# Access Compliance Report

## Public Rights-of-Way

### (Curb Ramps)

Intersection ID: 12848	Main Street: S_MINT_ST	Cross Street: W_PALMER_ST	Location: S
ADA ID: C8E23CD0F1BF	Ramp Type: PerpDiag	Initial Pass/Fail: Fail	Overall Compliance: No
			Severity Score: 41.25

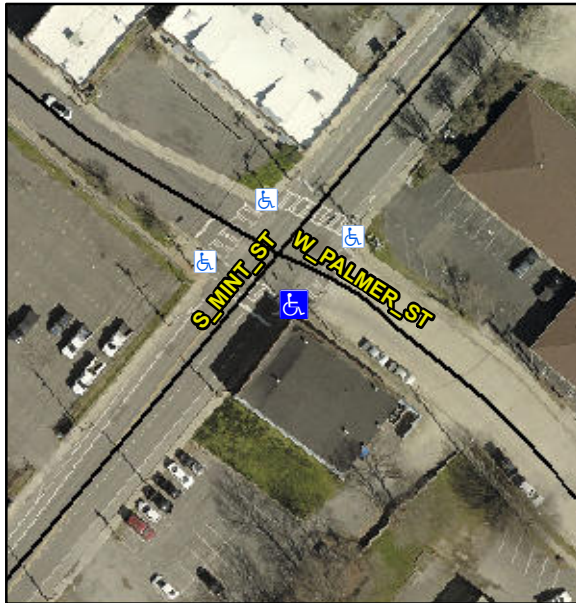
**R304.2.2, R304.5.3, R302.7**

Compliance	Description	Data	Compliance	Description	Data
N/A	Ramp Length (in)	42.0	No	Ramp Slope (%)	12.6
Yes	Ramp Width (in)	48.0	No	Ramp XSlope (%)	2.9
N/A	Flare Type LT	N/A	N/A	Flare Type RT	N/A
N/A	Flare Slope LT (%)	N/A	N/A	Flare Slope RT (%)	N/A
N/A	Flare Traversable LT?	N/A	N/A	Flare Traversable RT?	N/A
N/A	Landing Length (in)	N/A	N/A	DWS Provided?	N/A
N/A	Landing Width (in)	N/A	N/A	DWS Contrast?	N/A
N/A	Landing Slope (%)	N/A	N/A	DWS Length (in)	N/A
N/A	Landing X Slope (%)	N/A	N/A	DWS Full Width?	N/A
N/A	Landing Curb? (Y/N)	N/A	N/A	DWS Offset (in)	N/A
N/A	Shared Landing?	N/A			
N/A	Gutter Ponding?	N/A	N/A	Gutter Slope (%)	N/A
N/A	Gutter Lip Ht (in)	N/A	N/A	Gutter X Slope (%)	N/A
N/A	Painted X Walk1?	Yes	N/A	Painted X Walk2?	Yes
	X Walk 1 Direction	To NE		X Walk 2 Direction	To NW
N/A	X Walk 1 Width (in)	82.0	N/A	X Walk 2 Width (in)	113.0
	X Walk 1 Slope (%)	0.6		X Walk 2 Slope (%)	2.1
	X Walk 1 X Slope (%)	0.5		X Walk 2 X Slope (%)	0.4

N/A	Ramp inside XWalk1?	Yes	N/A	Ramp inside XWalk2?	Yes
	Road Slope (%)	1.2	N/A	Clear Space?	N/A
	Road X Slope (%)	0.3	N/A	Clear Space to XWalk (in)	N/A
N/A	Any Obstructions?	N/A	N/A	Storm Grate/Utility Hazard?	N/A
	Obstruction Type			Storm Grate/Utility Type	
		N/A			N/A
		No		Surface Condition? (G/P)	Poor

**Remove & Replace Curb Ramp With Two New Directional Ramps or Equivalent.**
